# MASTER DEVELOPMENT DRAINAGE PLAN FOR STERLING RANCH

JULY 2018

Project #09-002

SF-17-024

2018 STERLING RANCH MDDP		EXISTING HYDROLOGIC CONDITIONS MAP	
PROJECT NO. 08-035	FILE: \\dwg\Eng Exhibits\2018-MDDP-ExistCond\SWMap-REVISED.COLORS - .dwg	SCALE	DATE: 07-22-16
DESIGNED BY: DLM	DRAWN BY: DLM	HORIZ: NTS	VERT: NTS
CHECKED BY: VAS			DM1

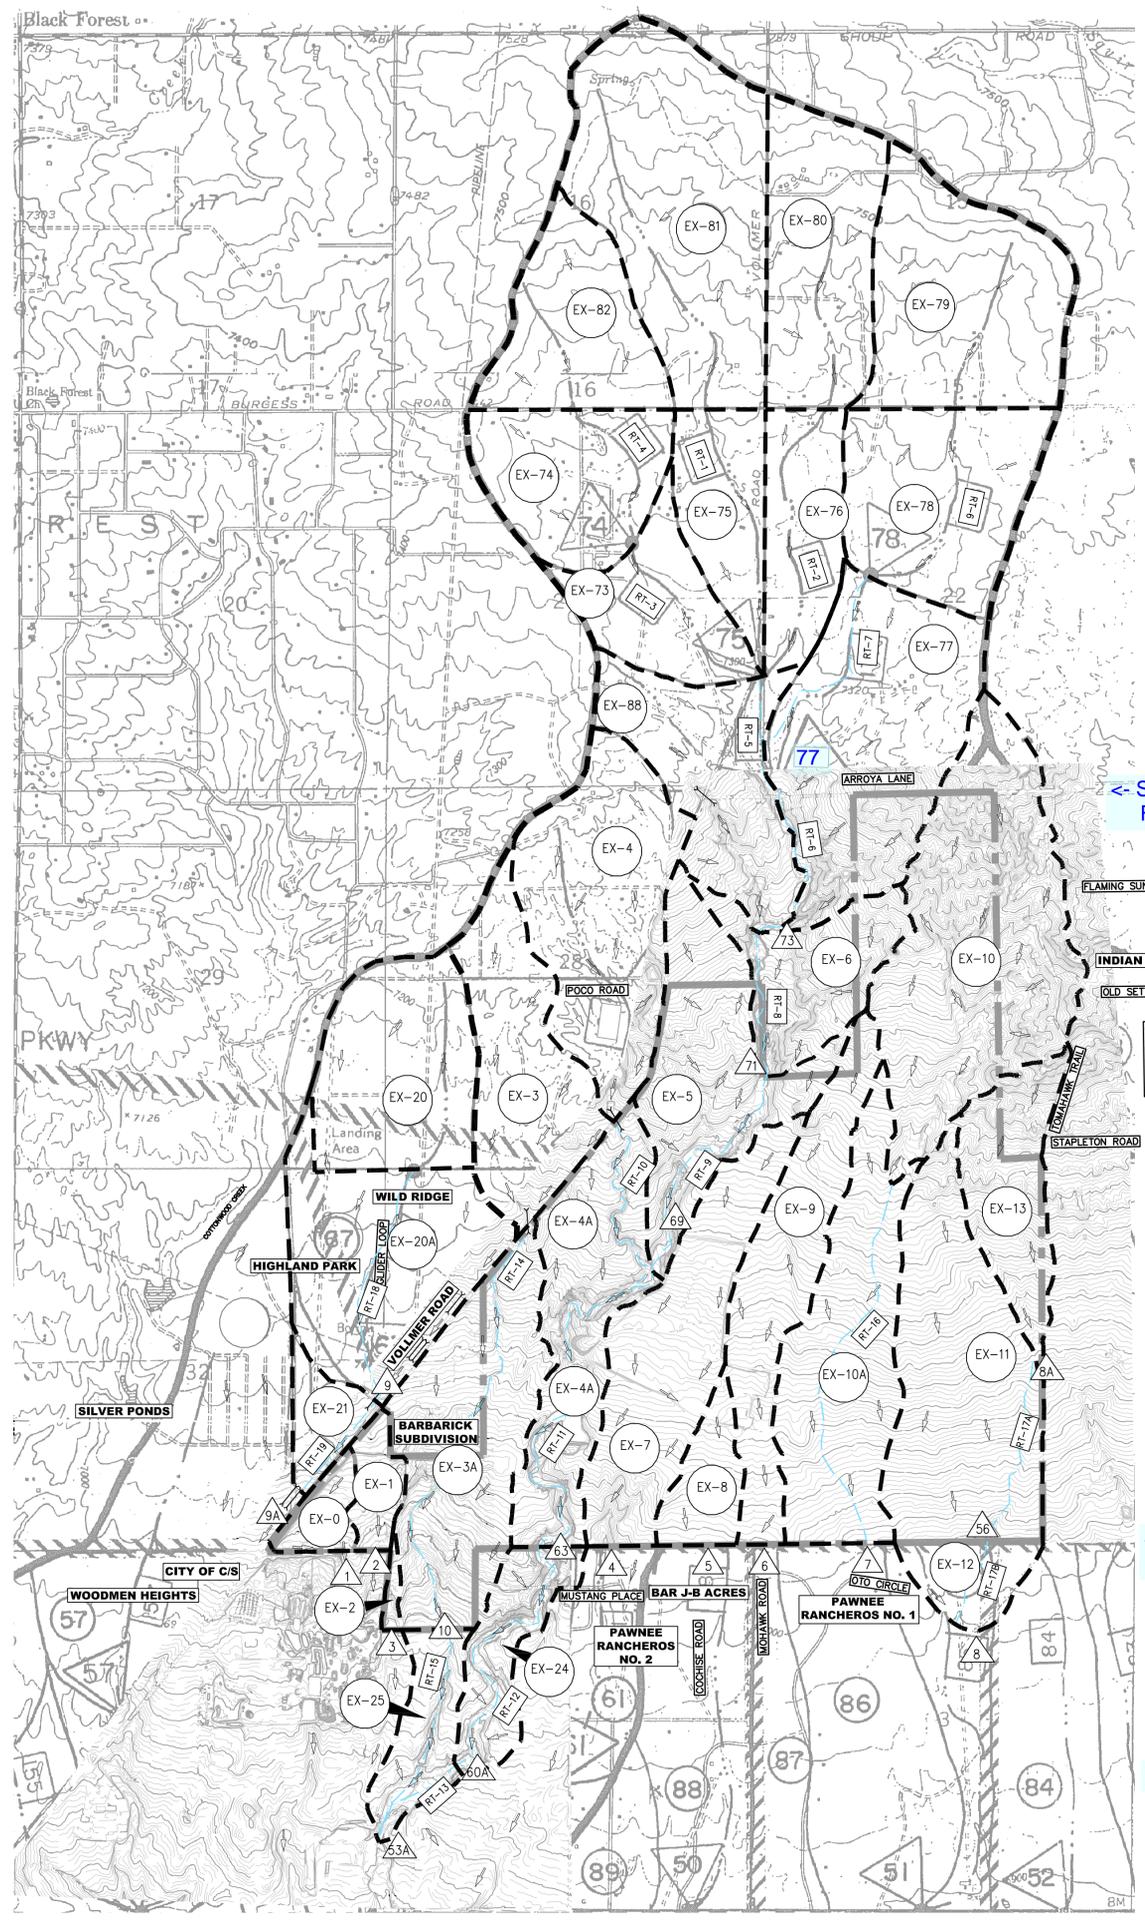
ISLAND CREEK / EAST  
FORK BASIN  
BOUNDARY  
Show

Add DBPS  
areas and  
flows at  
channel DPs.

Revise all values per modeling calculations.

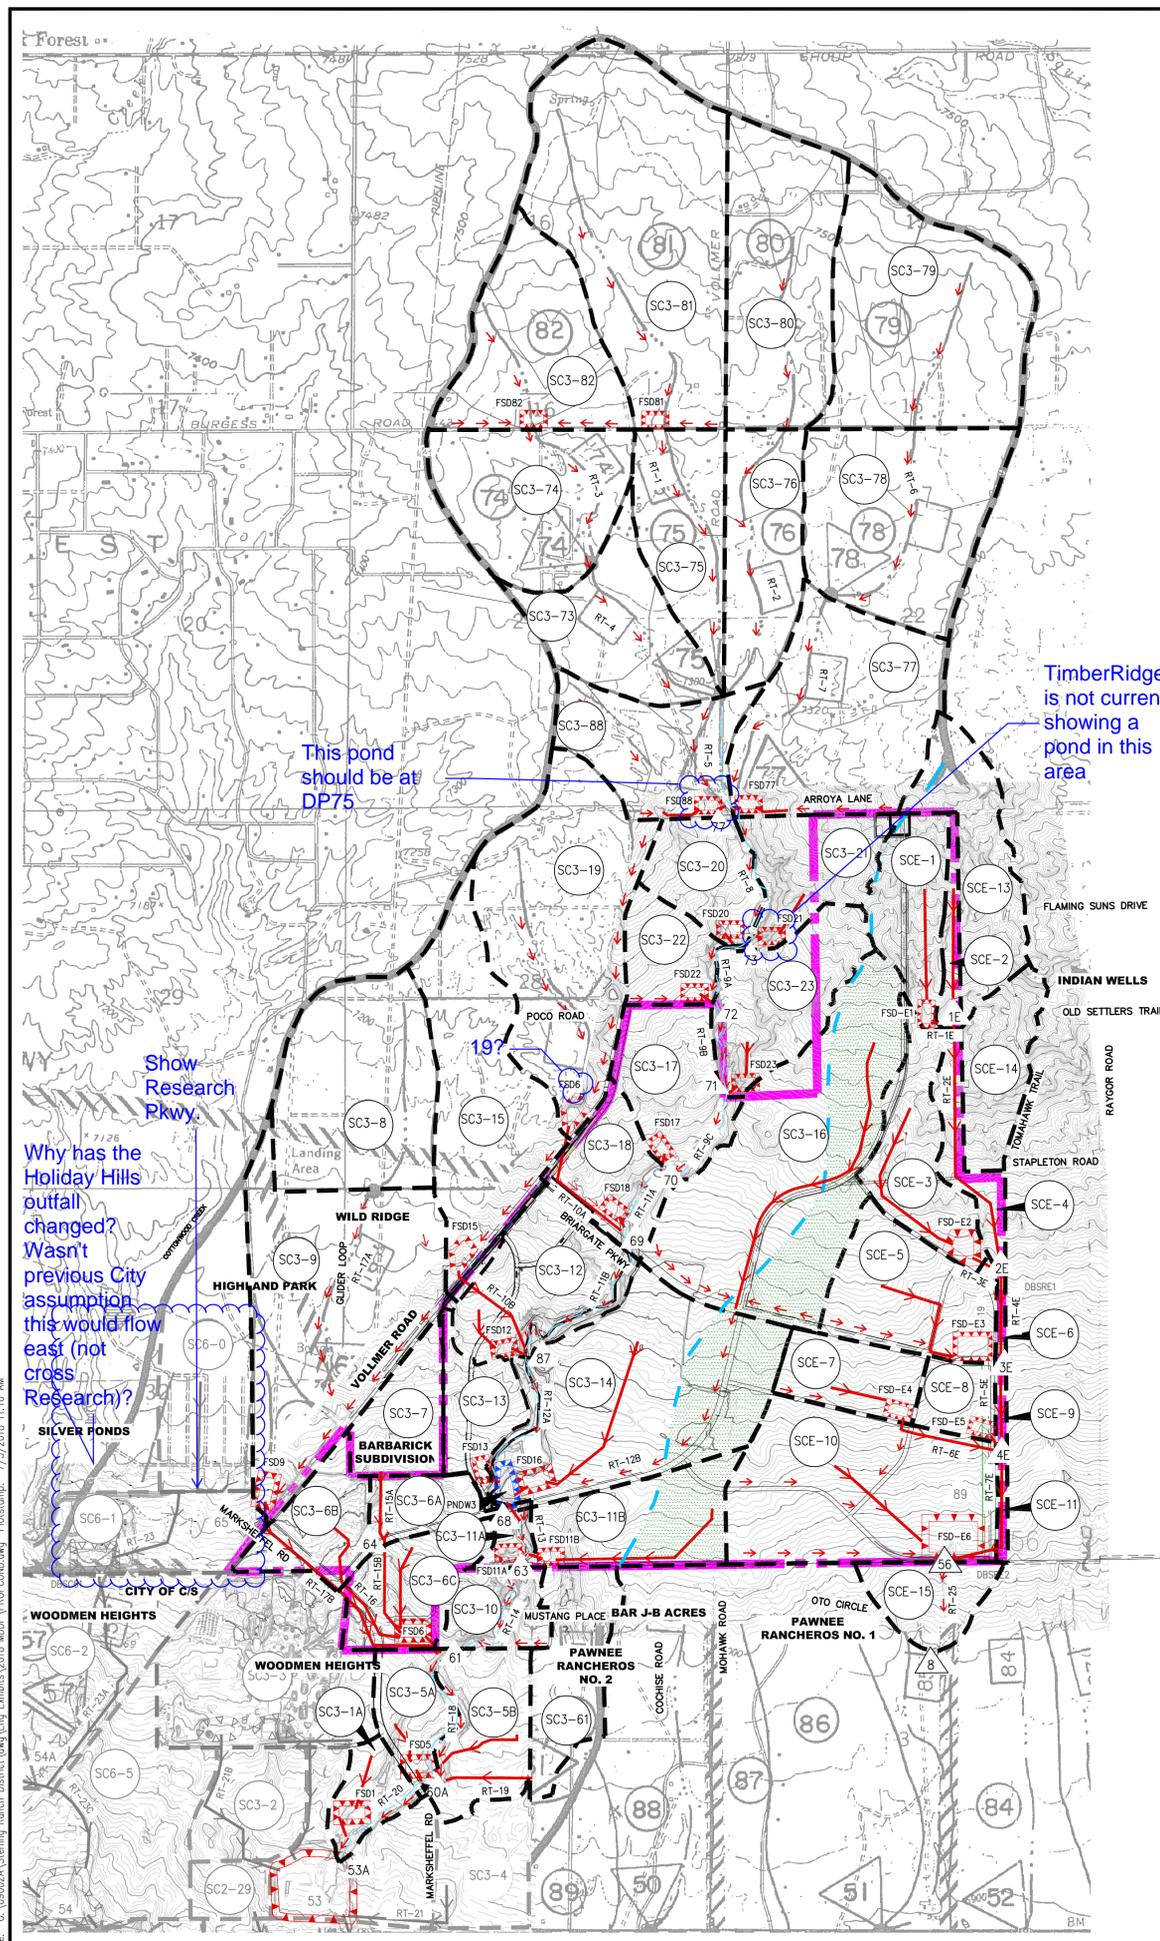
Add corresponding DP/general location after each pond ID.

Sand Creek Channel Study  
 Hydrologic Study - Future Conditions  
 Water Quality Control Volume Sizing Worksheet

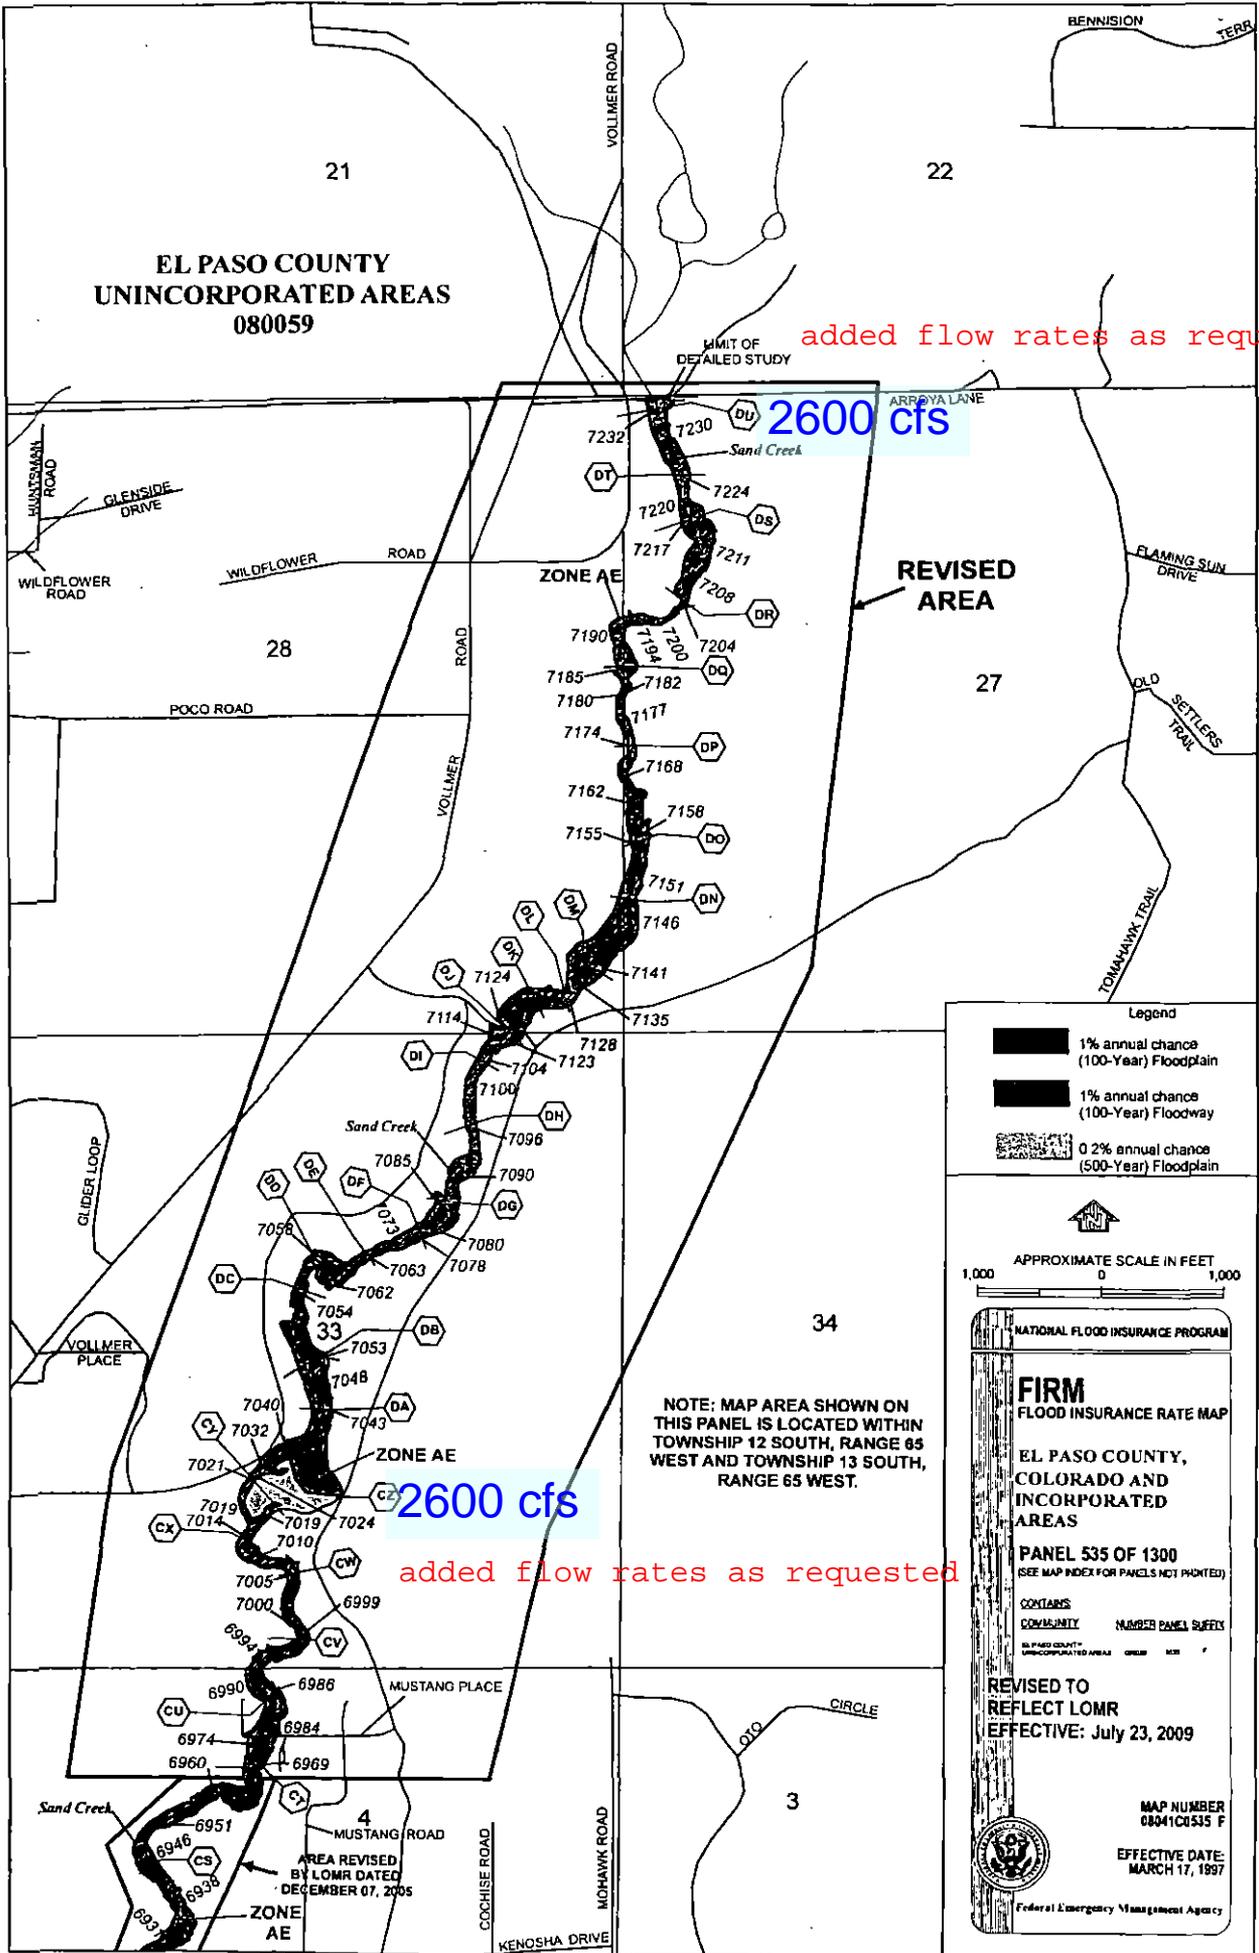
What about old SC8 / SC6-0 area?

flows planned to be directed to pond 6

**STERLING RANCH POND W-3**

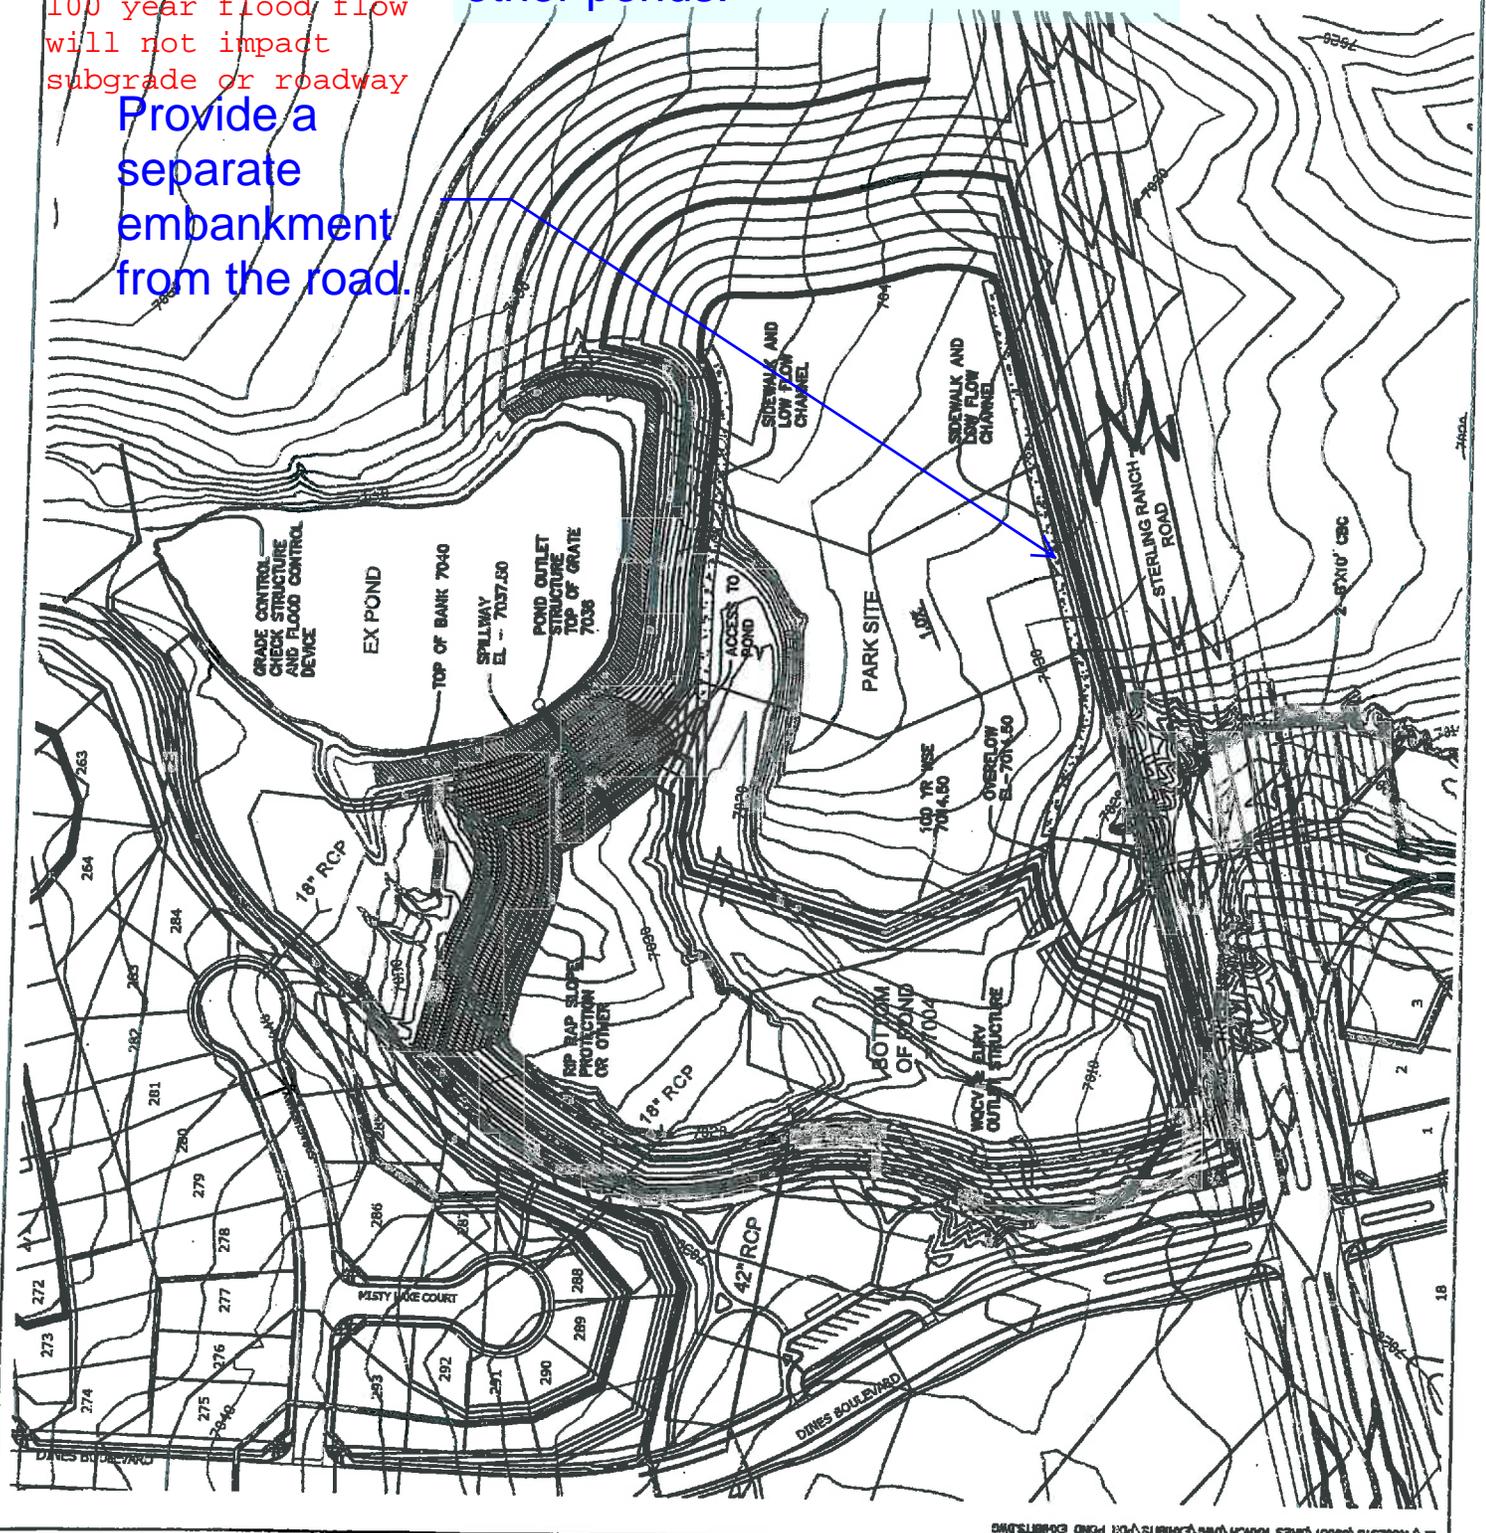
Provide a separate embankment from the road.

Move this up with the info for the other ponds.

100 year flood flow will not impact subgrade or roadway
